**RE: Northwest Land Park Phase 3 at The Mill (P17-056)**

WALKSacramento has reviewed the routing for Northwest Land Park Phase 3 at The Mill (P17-056) and we offer the following comments. The project proposes 185 condominiums on approximately 7.9 acres. Our comments are concerned with limited pedestrian access to the Cottages fronting private drives, a significant change to the alignment, configuration and shading of Setzer Run Trail, reduction in park space, and lack of trees for individual condos.

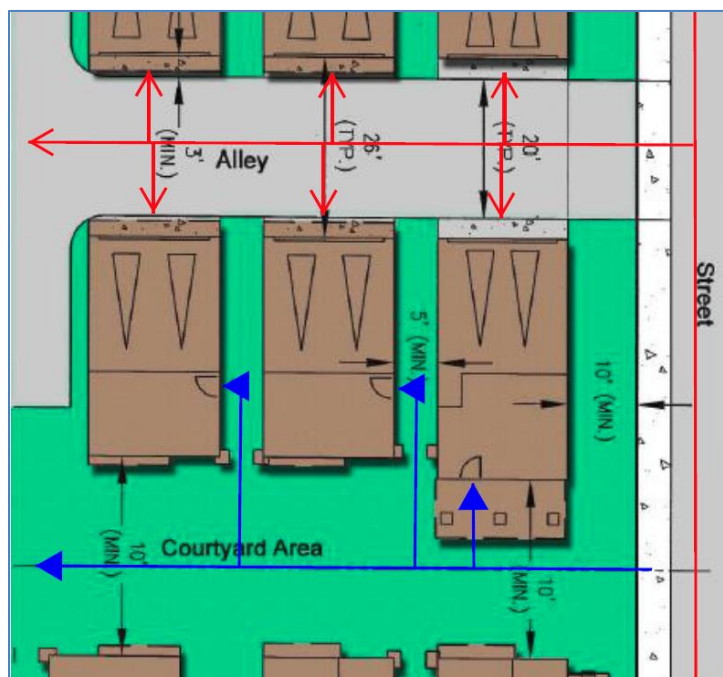
Buildings 38, 44, 45, 46, 47, 53, 54, 55, 56, 62, 63, 64 and 65, and 40, 43, 48, 52, 57, 61 and 66 have pedestrian access via driveways instead of sidewalks or courtyards. This in conflict with the Northwest Land Park PUD Guidelines (Sections 2.6.1 and 3.5) and it may, depending on the design of the walkway-private alley transition, preclude universal access to the homes. As we mentioned in our letter on Phase 2B, there are no well-defined pedestrian pathways to the interior condos – this includes connections to the condos from the street and from Setzer Run Trail. Below is a portion of the single family condos plot plan in the PUD Guidelines that we've marked up to indicate expected travel ways by pedestrians (blue lines) using courtyards and vehicles (red lines) using alleys.

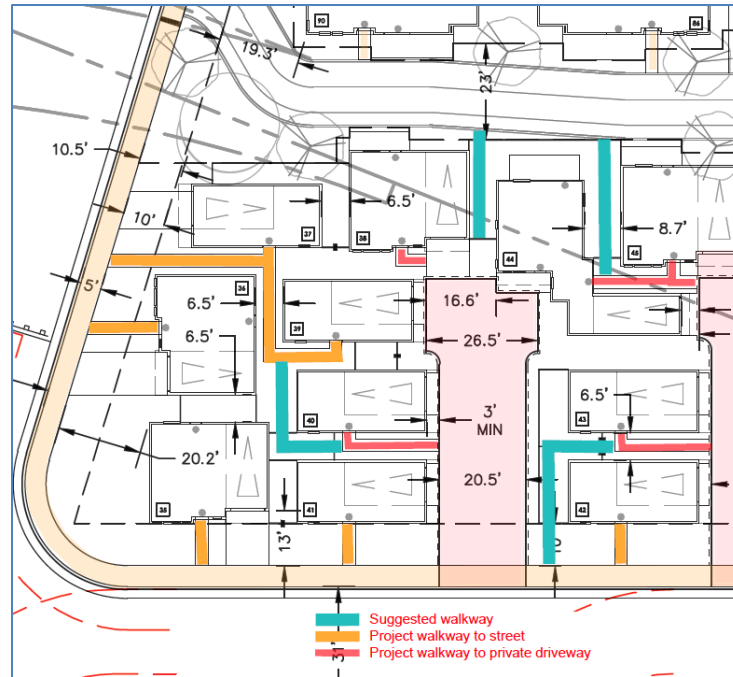
Although the separation distances between Cottages buildings are small, we request that the site plan be closely reviewed to determine the feasibility of including walkways to each of the buildings. Our initial review of the façades that face each other suggests walkways to every house could be implemented without a lack of “eyes on the walkway” or creating privacy concerns. Below is an illustration of one section. Suggested walkways are aqua colored, project walkways to the street are orange, and project walkways to private drives are red.
